SUBJECT: Forwards revised FSAR figures documenting analyses of SER
 Confirmatory Issue 1 re final pipe break locations & design
 of pipe whip restraints. Final break locations based on
 completion of as-built programs & final stress analysis.

Subject: NUCLEAR PROJECT NO. 2
SAFETY EVALUATION REPORT, CONFIRMATORY
ISSUE (1) BREAK LOCATIONS

The subject confirmatory issue requires submittal of the results of analyses to determine final pipe break locations and final design of pipe whip restraints. Attached are the revised FSAR figures documenting these analyses. It should be noted that these revisions indicate break locations based on the "status as built" stress analysis with thermal and fatigue loads. The "status as built" is not a final "as built" configuration; however, the Supply System does not anticipate any significant differences. Hence, the stress analysis and resulting pipe break locations in the attached figures, although not based on a final "as built", will not differ significantly from the final break locations. The final break locations will be based on completion of the "as built" program and the final stress analysis. Although no changes are anticipated, the Supply S

WASHINGTON PUBLIC POWER	STANDARD, LIQUID CONTROL	FILED
SUPPLY SYSTEM, NUCLEAR	KINETIC	3.6-19a
PROJECT NO. 2

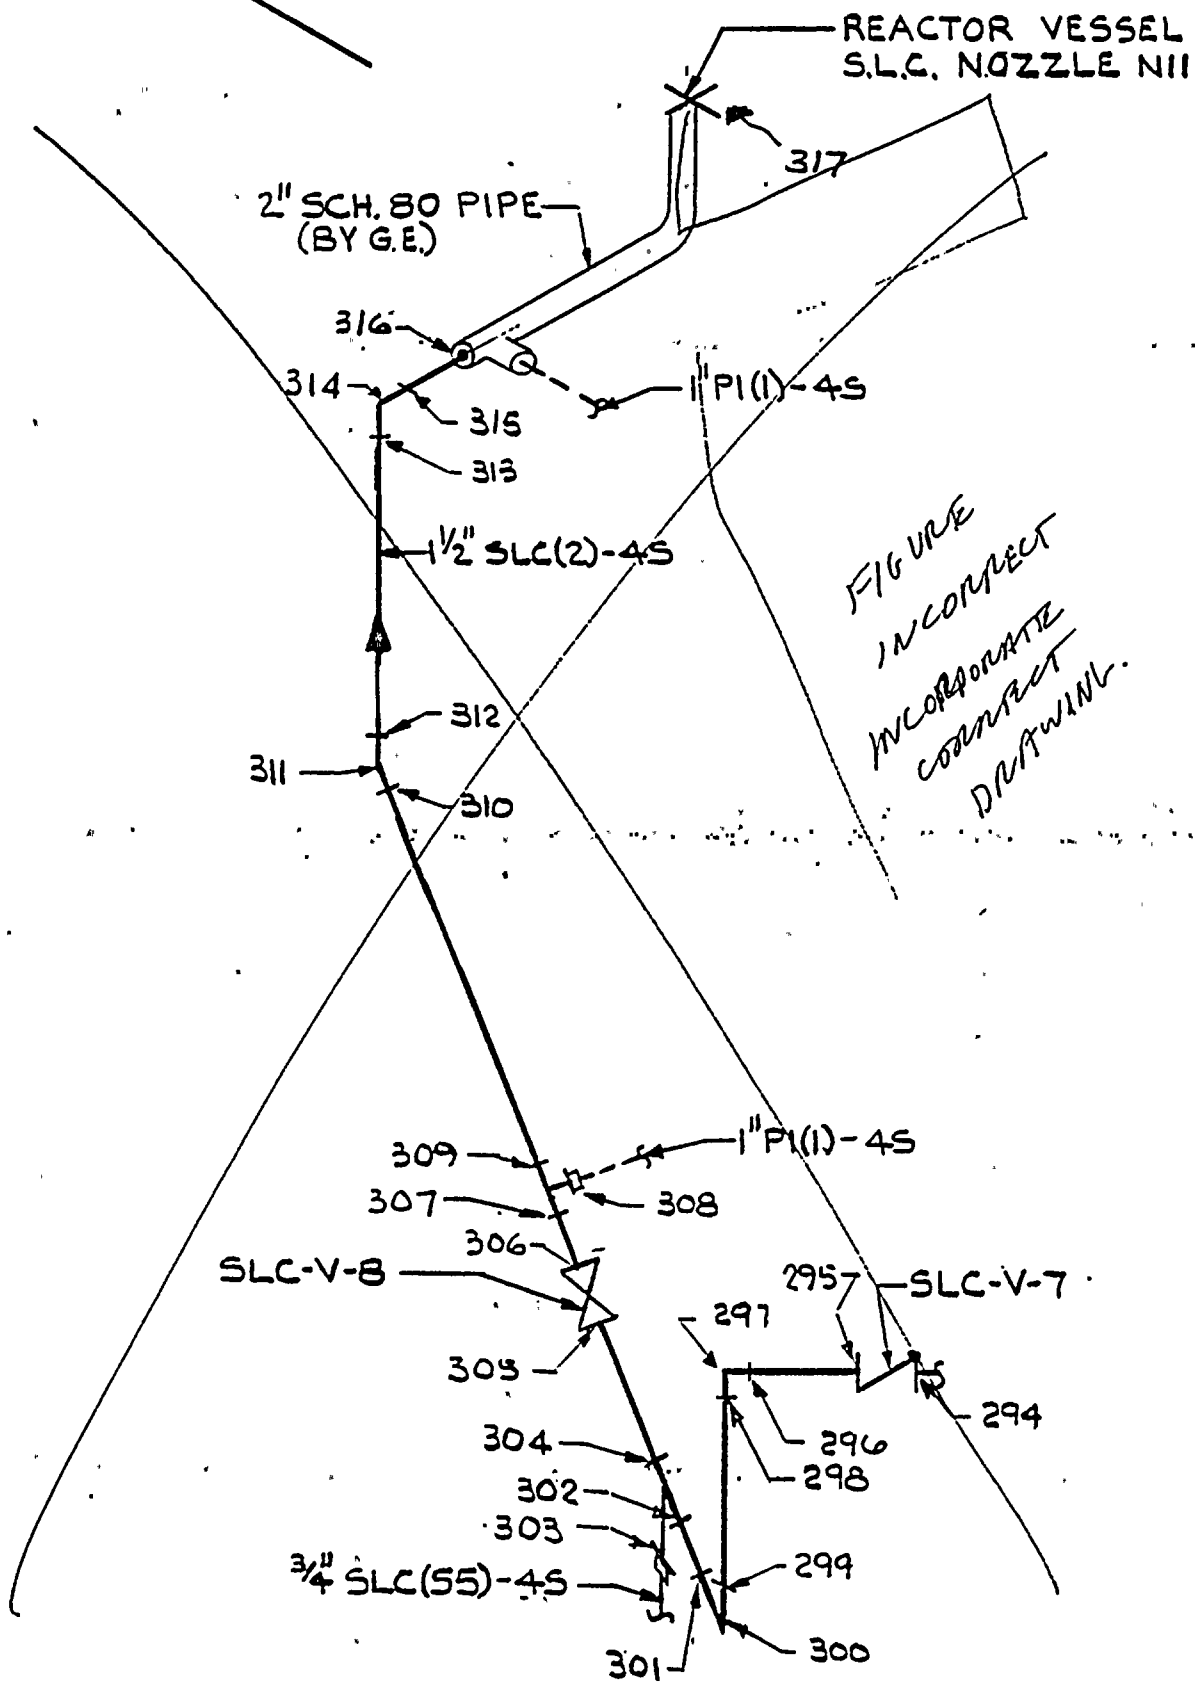
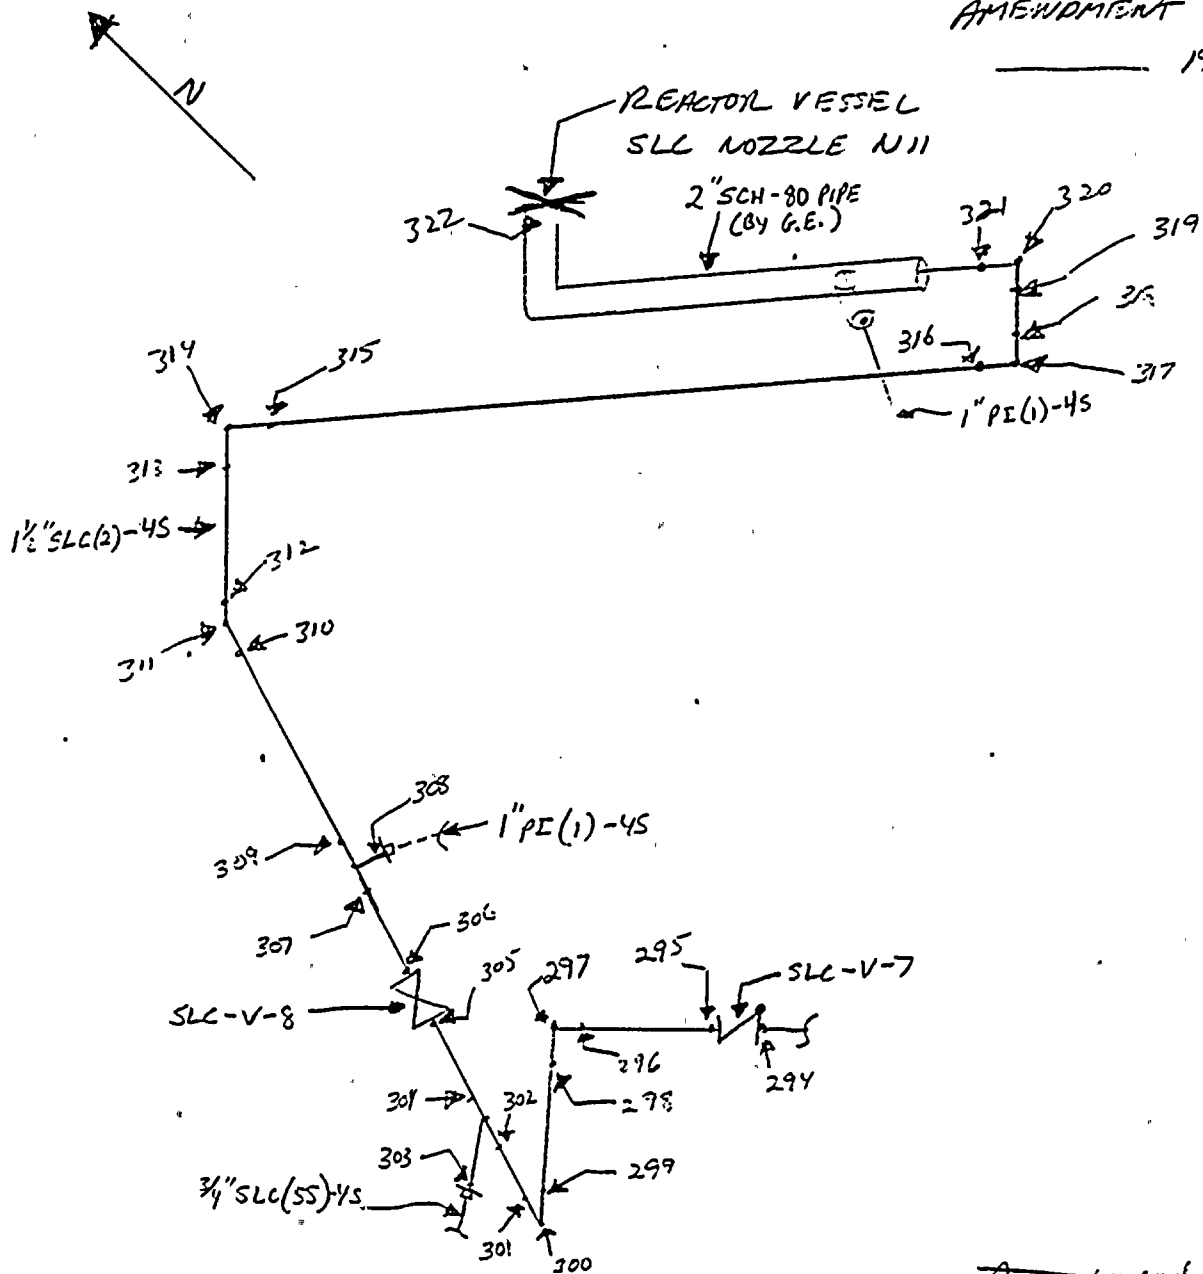
SUMMARY OF POSTULATED PIPE BREAK LOCATIONSCIRCUMFERENTIAL BREAKS

~~Node 419~~
~~Node 420~~
~~Node 421~~
~~Node 423~~
~~Node 424~~
~~Node 426~~
Node 427.
~~Node 428~~
~~Node 429~~

LONGITUDINAL BREAKS

~~Node 422~~
~~Node 425~~

SUMMARY OF POSTULATED PIPE BREAK LOCATIONSCIRCUMFERENTIAL BREAKSNODE 333

~~Node 340~~
~~Node 341~~
~~Node 342~~
~~Node 343~~
Node 344
~~Node 345~~
~~Node 347~~
~~Node 348~~
~~Node 350~~
~~Node 352~~
~~Node 365~~
Node 366
Node 367
Node 368
~~Node 369~~
~~Node 370~~

NODE 357

~~Node 372~~
Node 373
~~Node 375~~
~~Node 377~~
Node 379
~~Node 380~~
Node 381
~~Node 381A~~
~~Node 381B~~
~~Node 382~~
~~Node 383~~
~~Node 384~~
Node 385
~~Node 386~~
~~Node 387~~

~~Node 388~~
~~Node 389~~
~~Node 389A~~
~~Node 389B~~
~~Node 390~~
Node 391
~~Node 392~~
~~Node 393~~
Node 394
Node 395
Node 396
~~Node 397~~
~~Node 399~~
~~Node 400~~
~~Node 402~~

LONGITUDINAL BREAKS

~~Node center of [341, 342, 343] (TEE)~~

~~346~~
~~349~~

~~Node center of [384, 385, 386] (TEE)~~

~~374~~
~~371~~

~~Node center of [366, 367, 368] (TEE)~~

~~Node center of [394, 395, 396] (TEE)~~

~~390~~
~~401~~

~~Node center of [389, 389A, 390] (TEE)~~

~~Node center of [380, 381, 381A] (TEE)~~

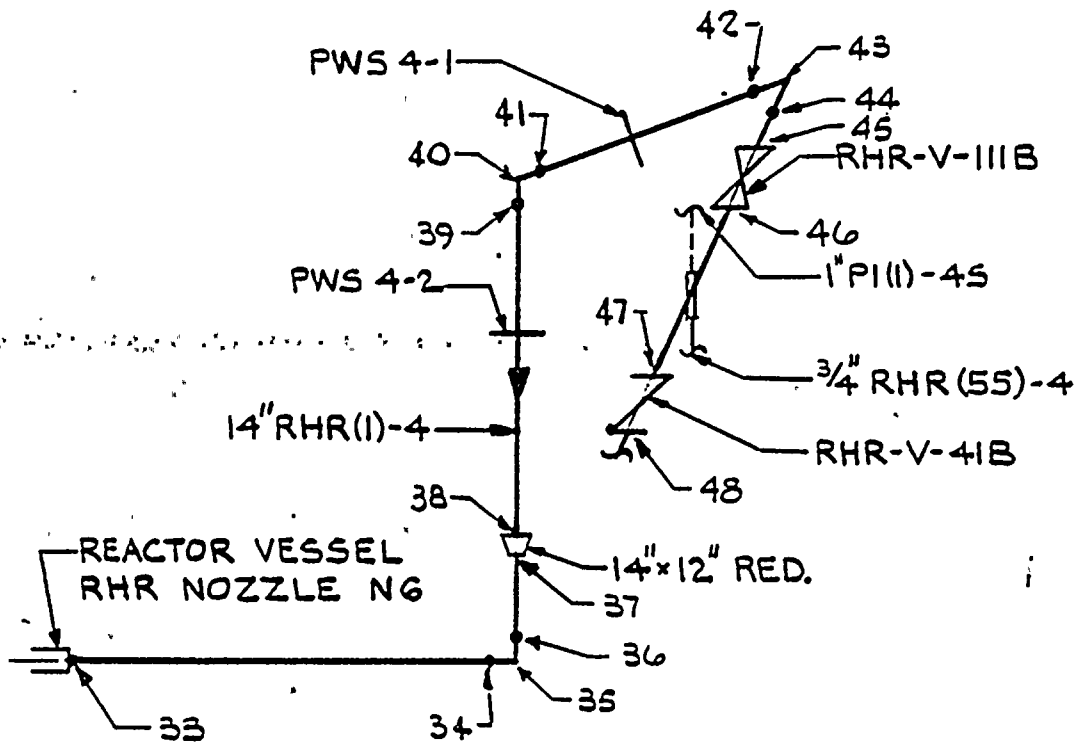
SUMMARY OF POSTULATED PIPE BREAK LOCATIONSCIRCUMFERENTIAL BREAKS

Node 17.
Node 18.
Node 20.
~~Node 21~~
~~Node 22~~
~~Node 23~~
~~Node 25~~
Node 26.
Node 28.
~~Node 29~~
~~Node 30~~
Node 31.

LONGITUDINAL BREAKS

Node 19.
~~Node 24~~
Node 27.

<p>WASHINGTON PUBLIC POWER SUPPLY SYSTEM NUCLEAR PROJECT NO. 2</p>	<p>RESIDUAL HEAT REMOVAL LPCI MODE (LOOP C) ISOMETRIC</p>	<p>FIGURE 3.6-22a</p>
--	---	---------------------------

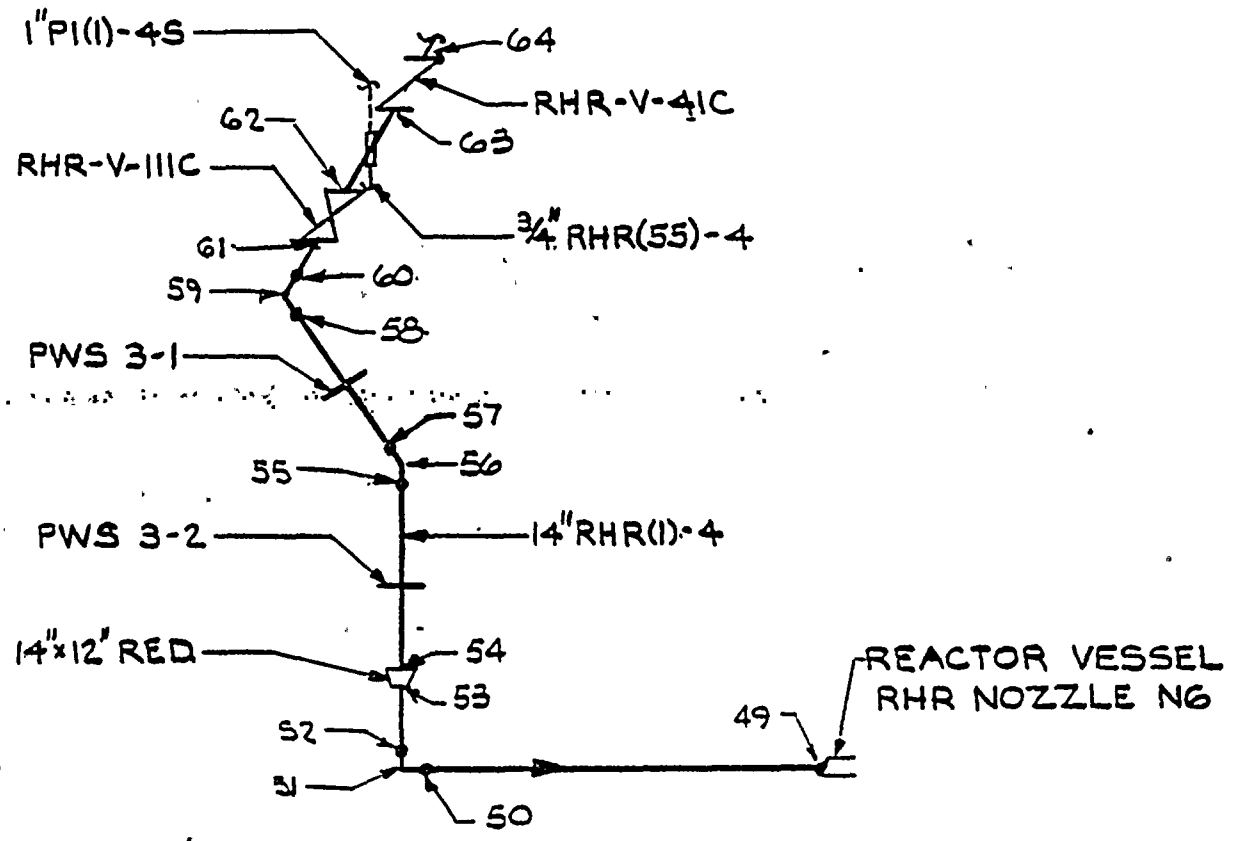
SUMMARY OF POSTULATED PIPE BREAK LOCATIONSPERIPHERAL BREAKS

Node 33•

Node 34•

Node 36•

~~Node 37~~~~Node 38~~~~Node 39~~~~Node 41~~

Node 42•

Node 44•

~~Node 45~~~~Node 46~~

Node 47•

LONGITUDINAL BREAKS

Node 35•

~~Node 40~~

Node 43•

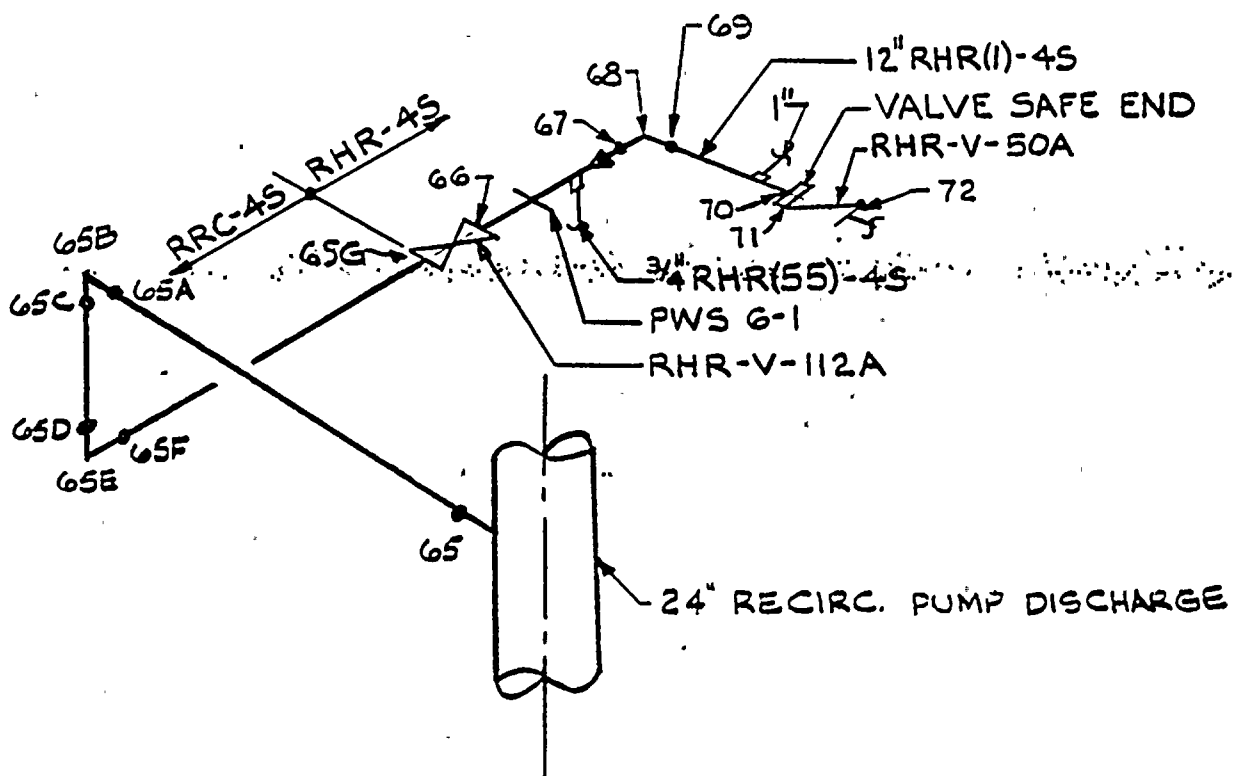
SUMMARY OF POSTULATED PIPE BREAK LOCATIONSCIRCUMFERENTIAL BREAKS

Node 49•
Node 50•
Node 52•
~~Node 53~~
~~Node 54~~
~~Node 55~~
~~Node 57~~
Node 58•
Node 60•
~~Node 61~~
~~Node 62~~
Node 63•

LONGITUDINAL BREAKS

Node 51•
~~Node 56~~
Node 59•

FIGURE
3.6-24a

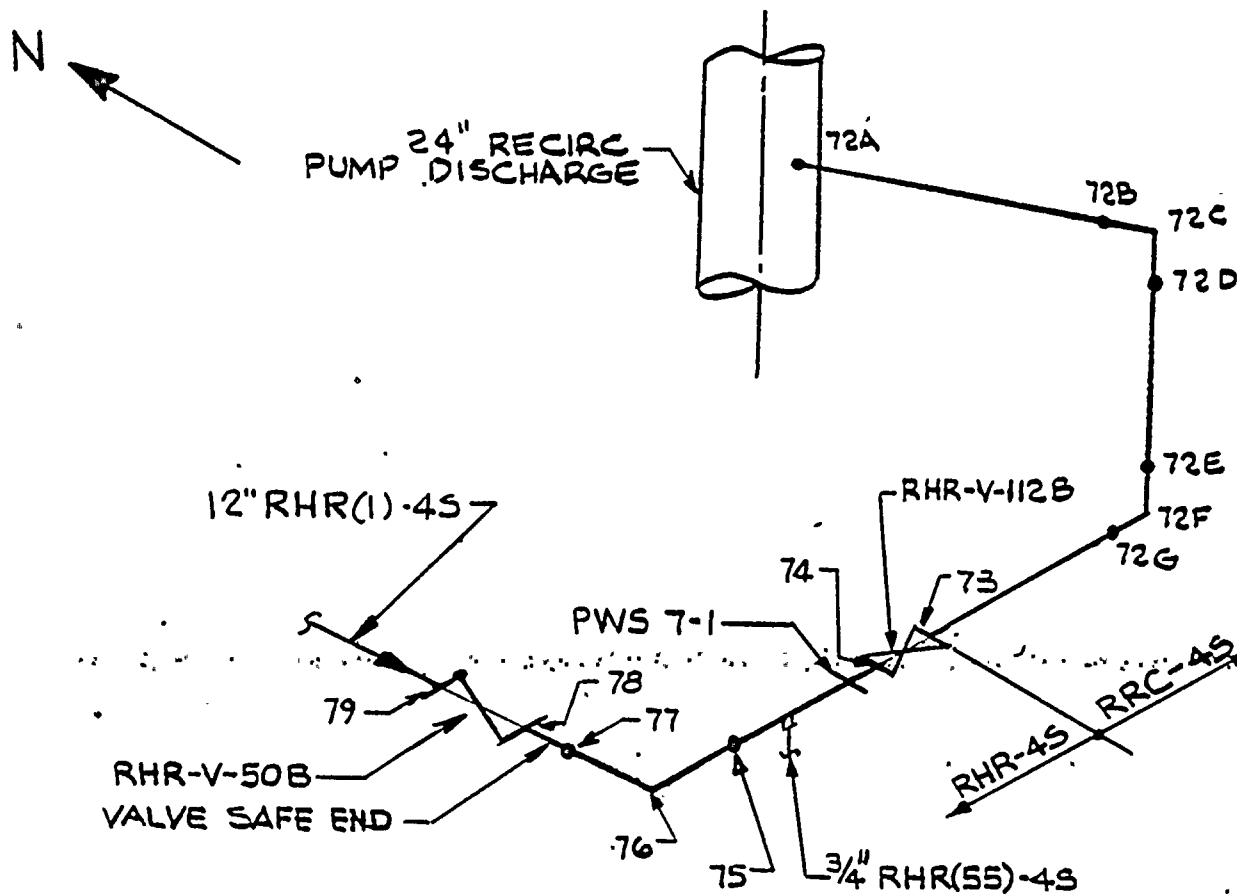
SUMMARY OF POSTULATED PIPE BREAK LOCATIONSCIRCUMFERENTIAL BREAKS

Node 65•
Node 65A•
Node 65C•
~~Node 65D•~~
~~Node 65F•~~
Node 65G•
Node 66•
Node 67•
Node 69•
~~Node 71•~~
NODE 70

LONGITUDINAL BREAKS

Node 65B•
~~Node 65E~~
Node 68•

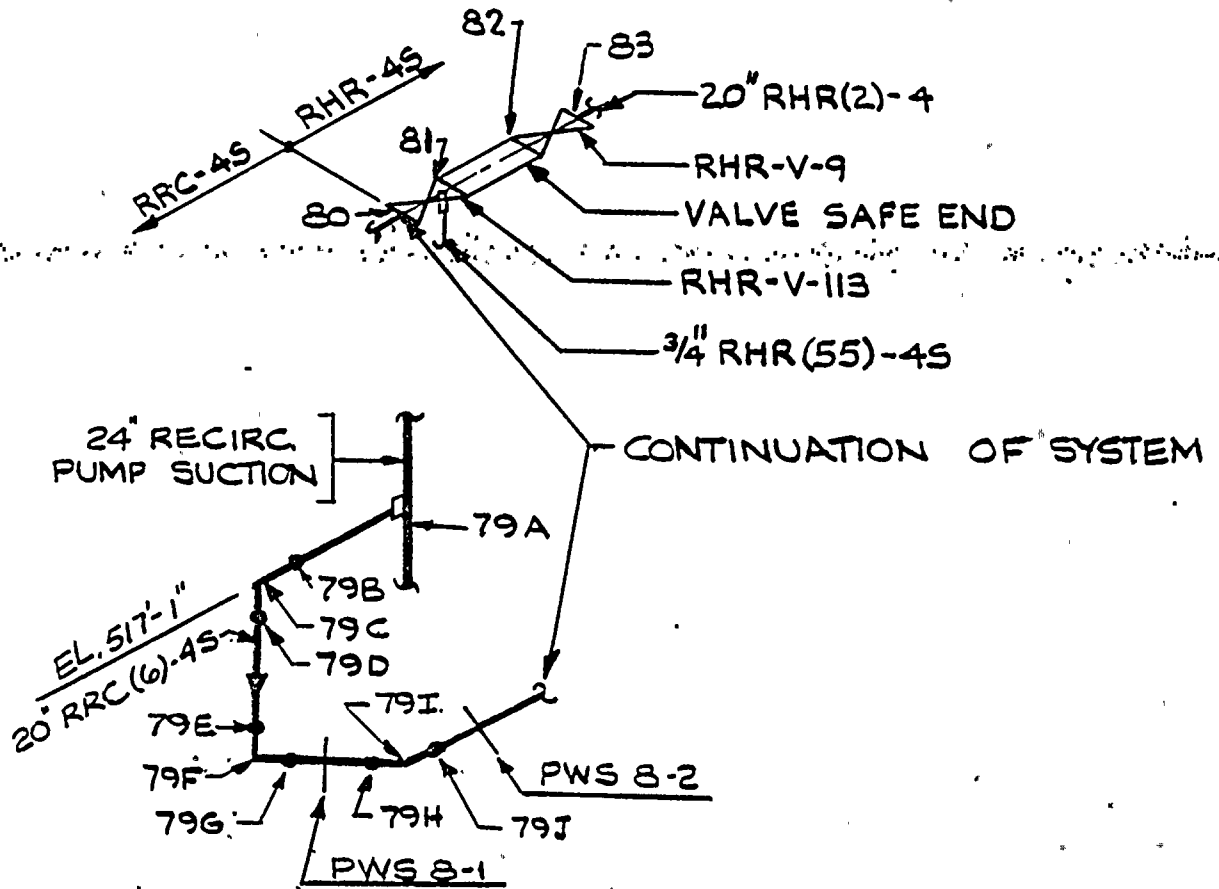
SUMMARY OF POSTULATED PIPE BREAK LOCATIONSCIRCUMFERENTIAL BREAKS

Node 72A •
Node 72B •
Node 72D •
Node 72E •
Node 72G •
~~Node 73~~
~~Node 74~~
Node 75 •
~~Node 78~~
Node 77

LONGITUDINAL BREAKS

Node 72C •
Node 72F •
Node 76 •

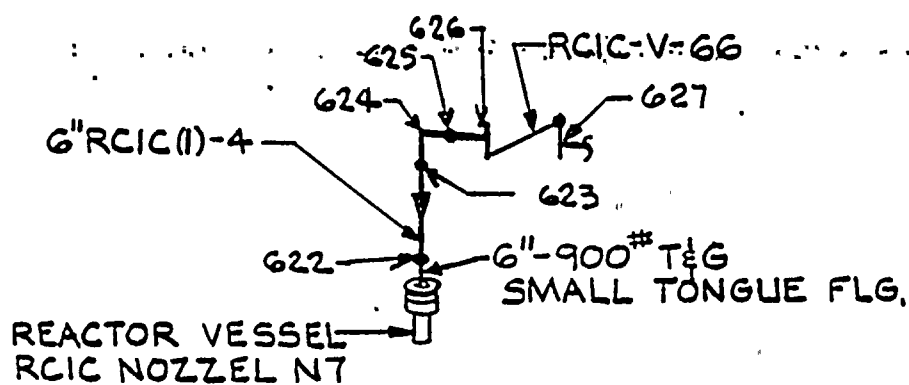
SUMMARY OF POSTULATED PIPE BREAK LOCATIONS

CIRCUMFERENTIAL BREAKS

Node 79A •
~~Node 79B •~~
~~Node 79D •~~
Node 79E •
Node 79G •
Node 79H •
Node 79J •
~~Node 80~~
~~Node 81~~
Node 82 •

LONGITUDINAL BREAKS

~~Node 79C •~~
Node 79F •
Node 79I •

FIGURE
3.6-
26b

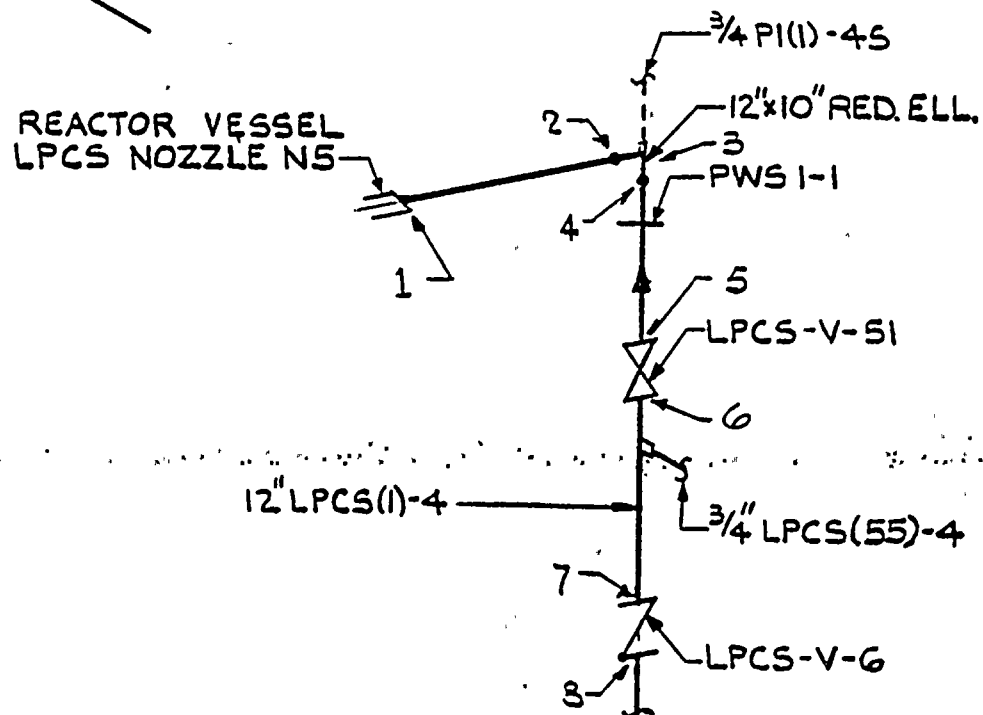
RCIC RPV HEAD SPRAY ~~SHUTDOWN~~

~~RESIDUAL HEAT REMOVAL SHUTDOWN~~
~~COOLING SUPPLY~~
